BARNSTAPLE TOWN

Notes on an ex-BR(S) Signal Box Diagram

These notes relate to a copy of a signal-box diagram for **Barnstaple Town** provided some years ago to the Signalling Record Society (SRS) from the microfilmed records of British Railways (Southern Region) (BR(S)). A scanned image of reduced quality is included in this document for ease of reference, but access to the original would be required for a more detailed study of some of the items mentioned below.

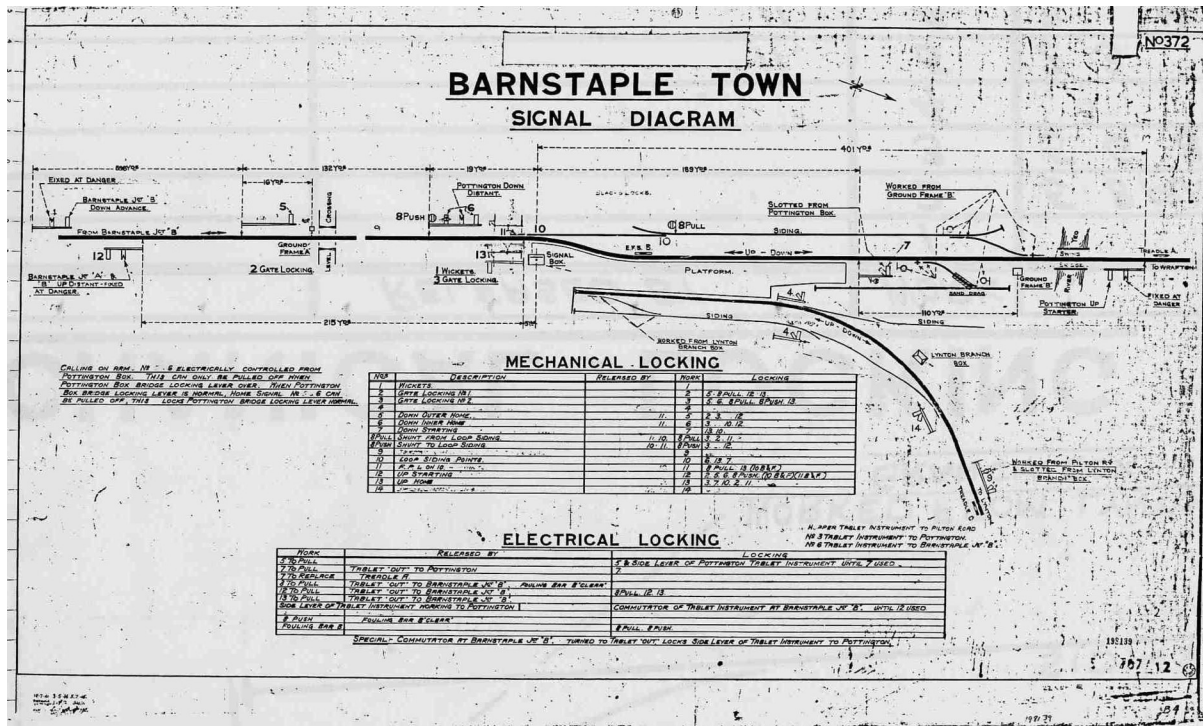
1. Date. At first glance the diagram would *appear* to date between 1923 and 1935, as it shows the L&BR still in place with its signals slotted from the SR box. Yet the diagram has amendment dates from the 1940s in the bottom left-hand margin, the 'West' box at Barnstaple Junction has been re-designated as 'B' (a change which took place in October 1949), the sand-drag (provided after closure of the transfer siding) is in place at the north end, and there is evidence of a BR(W) 'S..../12' number in the bottom right-hand corner. All these items suggest that the diagram had been maintained until at least the early-1960s, but why then did it continue to show so much of the former L&BR installation? Had someone perhaps dutifully carried out various amendments at different times after 1935 without realising that the diagram had not been amended previously to reflect the closure of the L&BR?

2. Diagram Number. The diagram bears the number 372 in the top right-hand corner, but there are references to 343 in the amendment details in the bottom left-hand margin. There is evidence of a BR(W) 'S' number (7??) in the bottom right-hand corner, but it is believed that the replacement BR(W) diagram for the 1967 alterations was numbered S3519. Given that this diagram came from a BR(S) source, then the *assumption* is as follows:-

3. Slot levers. In the original 1898 installation lever 4 was the Down Distant, 14 was the Up Distant and 9 was a 'safety bar' situated between signals 5 and 6. (It is not known if these levers were already spare by the time that they were re-used for 'slots' on the L&BR signals, or were changed from their original functions for that specific purpose, but there is a *presumption* that the latter situation was the case.) Examination of the 'Released By' column in the Mechanical Locking table shows evidence of deleted entries for 4 and 14 that are consistent with their original use as distant signals.

However there is evidence also of deleted entries in the 'Locking' column, which is not something to be expected normally for distant levers. Those entries *appear* to show that 4 locked 14, 9 locked 14, and 14 locked both 4 and 9. All those entries would be consistent with the *assumed* locking requirements for the period when those levers worked slots on the L&BR signals (*see note below*). However, none of the entries for levers 4, 9 or 14 have any information in the 'Description' column, which – combined with the fact that the 'Locking' details have been erased – would suggest that the Mechanical Locking table has been amended *after* the closure of the L&BR in 1935. In which case, why are the slot numbers still marked against their respective L&B signals?

4. Down Outer Home (5). This signal was renewed on 21-July-1925 (SR Signal Instruction 23/1925). The SI states that the existing 'C' and 'T' indicators (for the Permanent Speed Restriction over the River Taw viaduct) were re-fixed on the new post, and traces of what are *presumed* to be those circular indicators are evident on the diagram on either side of the lower part of the post. The PSR indicators were abolished on 15-April-1931 (SR SI 13/1931). The Down Outer Home was renewed again on 5-October-1948 (SR SI 37/1948).

The 'Calling On' arm under the Down Outer Home was abolished on 21-July-1925 (SR SI 23/1925) when the Down Outer Home was renewed. The 'Calling On' arm under the Down Inner Home remained in use until both it and the Down Inner Home were abolished as part of the 1967 alterations. The diagram shows the arm below the Down Inner Home and there is 'trace' evidence for the arm below the Down Outer Home. A careful examination of the block of text to the left of the Mechanical Locking table will show further 'trace' evidence where the text has been amended to delete entries for arm 5 and to change other words from plural to singular forms.

6. Safety Bar (9). In the 1898 installation there was a mechanical 'safety bar' installed about mid-way between the Down Outer Home and Down Inner Home signals and this was worked by lever 9. (A remnant of the erased '9' can be seen on the diagram close to the gap in the track.) Bearing in mind the alterations that would have occurred to the Mechanical Locking table for the changes relating to the later 'slot' levers, it would appear from the residual traces in the table that the reversal of lever 9 was required as a release for levers 8PULL and 13. (One may *presume* that, when the lever was reversed, the bar lifted and then fell again.) There is some evidence, but less clear, that lever 9 was locked by the use of 5, 6 or 8PUSH.

7. Loop Siding Points. In the 1898 installation the facing point leading into the loop siding was worked by lever 10, but the trap point at its exit was worked by lever 11. Both points had Black's 'economic' FPLs and traces of the deleted phrase '*Blacks Locks*' can be seen on the diagram just above those points. (A similar arrangement existed at the north end of the loop siding, controlled from GF 'B'.) It is not known why this lever arrangement was used, nor when it was altered, nor whether the alteration took place as part of some overall package of locking changes concurrent with the provision of the 'slot' levers.

reversal of lever 10 if the siding connection was fouled by a train on the platform line. However it is clear from the Electrical Locking table in the diagram that the later EFB had a different function, namely to lock lever 8 for the associated ground-signals. It is curious to note that, according to the Electrical Locking table, although the EFB locked both 8PULL and 8PUSH functions specifically, only 8PUSH is listed with the relevant 'Released By' requirement for the EFB to be 'clear' – there is no similar mention for 8PULL.

The diagram omits any ground-signal north of the ground-frame, and also the one in the 'six foot' by the Down Starting, yet shows all the others, so clearly there is some inconsistency here and it would be difficult to make an accurate assessment of the diagram date from that detail. No evidence has been found yet to suggest that any ground-signal was in fact mounted *on* the post of the Down Starting, as shown on the diagram, but – purely as speculation – it *might* have been a *post*-1940 change.

9. Sand Drag. The drawing marks a sand drag as part of the crossover connection to the up side 'transfer' siding, in a location which clearly makes the crossover unusable. According to SR SI 6/1940, the transfer siding and its associated ground signals were abolished on 3-April-1940, but the facing point on the main line was left in place to lead to a 40-feet sand drag. This is another example of a *post*-1935 amendment to the diagram which is incomplete, as the sand drag has been added but neither the siding nor its shunt signals have been erased.

was on the platform side of the platform line, but at some unknown date that signal was moved to the outside of the run-round loop siding. Then on 28-August-1929 (SR SI 33/1929) the signal was renewed and re-located on the platform, where it remained until 1935. There is no known photographic evidence, nor anything in SI 33/1929, to suggest that two separate signals were in use at any time, nor does there seem to have been any need for such an arrangement. It is *assumed* therefore that this is simply a drawing error.

11. L&BR FPLs. The L&BR used 'economic' facing point locks. A FPL is shown on the facing point close to the L&BR's Up Home, which leads into the run-round loop. There was also an FPL on the facing point close to the L&BR's Down Starting, which lead into the 'transfer' siding, but that is **not** shown. A FPL is shown also on the trailing point of the release crossover in the platform road, but there is no photographic evidence for that, nor would it appear to have been necessary. The reasons for these apparent inconsistencies on the diagram are not known.

12 L&BR Functions. The diagram marks specifically that the engine release crossover points are "*worked from Lynton branch box*", yet there is no similar annotation for the points for the 'transfer' siding or at the entrance to the loop. Likewise, the diagram marks that the lower ringed arm under the L&BR's Down Advanced Starting was "*worked from Pilton Rd and slotted from Lynton branch box*", but there is no equivalent annotation for the working of the slots on the Down Starting and Up Home from the ex-L&BR box.

A close examination of the diagram suggests that there had been a further instance of the phrase "*worked from Lynton branch box*" written in the space just below, and to the right of, the L&BR signal-box. This has been deleted along with the various 'arrows' which appear to have led from it towards the other L&BR signals and points. It is *assumed* therefore that this is another example of the diagram having been subject to an incomplete amendment at some *post*-1935 date.

The lower ringed arm was added on 30-August-1927 (SR SI 22/1927). It is unclear whether the figure '9' against the signal is meant to apply to both arms, or just the upper one, but there are faint traces of markings which *could* support the former arrangement. Certainly it has been *assumed* previously that the ringed arm also would have been slotted by '9' and therefore had three slots.

It is curious therefore that the lower arm alone is marked specifically "*worked from Pilton Rd and slotted from Lynton branch box*", as use of the term 'worked' tends to indicate that the signal is **not** controlled by the box on whose diagram it appears (in

14. Treadle 'A'. This treadle released a back-lock on lever 7. The treadle is shown on the diagram simply as being somewhere north of the swing-bridge. On an early GAP drawing it is shown as being between the south end of the swing-bridge and the facing point into the north end of the loop siding, but it has not been possible to find any 'trace' evidence on the SR drawing. A 1960s BR(S) diagram for Pottington signal-box includes a treadle identified as 'C' almost directly in front of GF 'B'. The precise position of this treadle therefore remains unclear.

15. Treadle 'C'. This treadle is marked on the L&BR line in advance of the Down Advanced Starting signal. Its purpose is unknown, as there is no other reference to it on the diagram, so it is unclear whether it served a function at Barnstaple Town or Pilton or both. It is *possible* that it may have been added in SR days to release a back-lock on the Down Advanced Starting slot 9, and therefore could have been listed in a deleted entry in the Electrical Locking table (see comments elsewhere in these notes about the Electrical Locking table).

For both 8PULL and 13 the 'Locking' entry for '2' is out of the normal ascending sequence and *appears* therefore to be a latter addition (re-using a space in the sequence in the case of 8PULL). Given that both signals used to be released by 9 (when that lever worked the safety bar), then *perhaps* it had been the case that 9 locked 2, so the direct locking between 8PULL/13 and 2 only became necessary after 9 was converted for use as a L&BR 'slot'? However there is less obvious evidence for any changes in the 'locking' entries for lever 2.

17. Electrical Locking Table. This shows evidence of some alterations in the BR period, as Barnstaple Junction West has been amended to 'B' in two places. There is a blank line (above the entry for 8PUSH) which has traces of a deleted entry where the first character in the 'Work' column *appears* to be '9'. As the entries in the lower part of the table appear to relate to later arrangements, then it is considered that any entry for '9' is more likely to date from the period when it was a 'slot' lever rather than the earlier safety bar. It is *suggested* therefore that this entry *may* have been *either*

18. ETT instruments. Block working to Pilton is listed as using 'Hopper No 1' instruments. This is a description unknown other than in SR documents about the L&BR line, whereas photographic evidence shows that in fact the L&BR used Tyer's No 7A instruments. Given the rarity of that pattern in the UK, it is *assumed* that the 'Hopper' description was a local term for what was otherwise an unknown type of instrument in the area.

19. Pilton. There are two places on the diagram where the signal-box at Pilton is described as 'Pilton Road' or 'Pilton RD', whereas other documents of the SR era refer to it as 'Pilton Yard'. Although also described variously as 'Pilton Bridge' or just 'Pilton', no other instances of 'Pilton Road' are known.
